# Product Change Notification

Date Issued :	November 06, 2023	PCN Number :	514521
Reason for Change :	Change Supplier		
Description of Change :	This notification is to inform you of remove holes for thinned section area which prevent the surface sink from this housing to improve moldability and productivity. For details, please see below.		
Assessment of Change :	First Article Inspection		
Planned Implementation Date :	May 06, 2024		
Sample Availability Date:	November 01, 2023		
Internal Molex Qualification Date :	October 26, 2023		
Last date to request Samples by Customer :	November 30, 2023		
Traceability Code Markings / Date :	Lot information on label

## Change in appearance due to remove holes

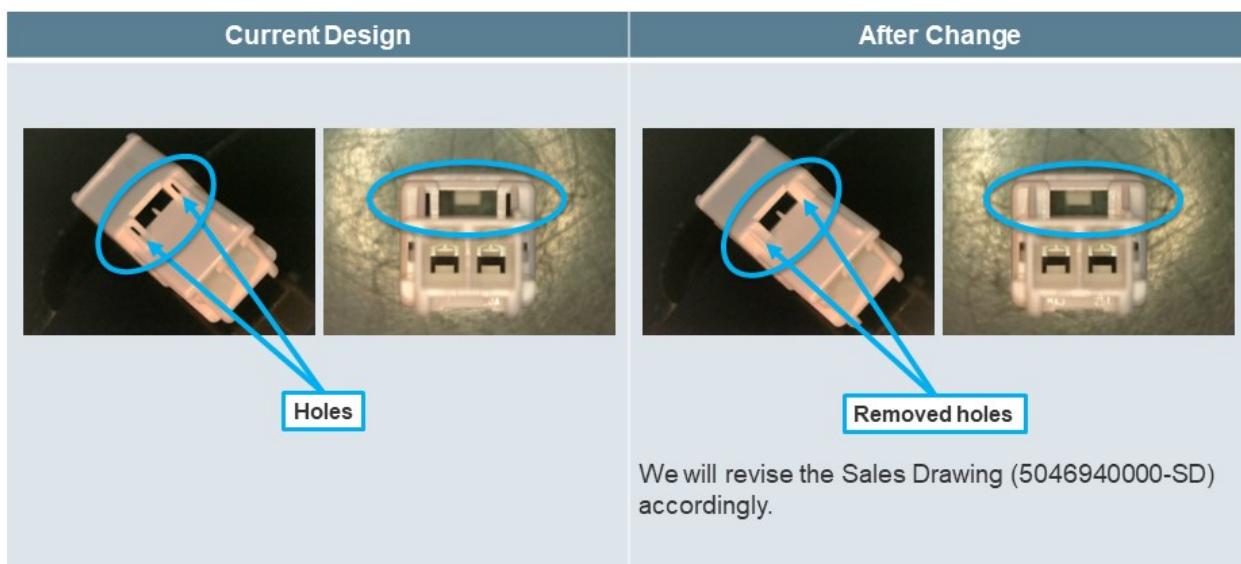
- Reason of Change
  - We would like to remove holes for thinned section area which prevent the surface sink from this housing to improve moldability and productivity. The molding die part that make up these holes will often break, so we would like to remove the holes.
- Product Impact
  - This change will be removed the holes. However, it has no impact to surface sink, fit and function after remove the holes.
- Part Number Impact
  - 504694 Series
- PPAP and samples available upon request
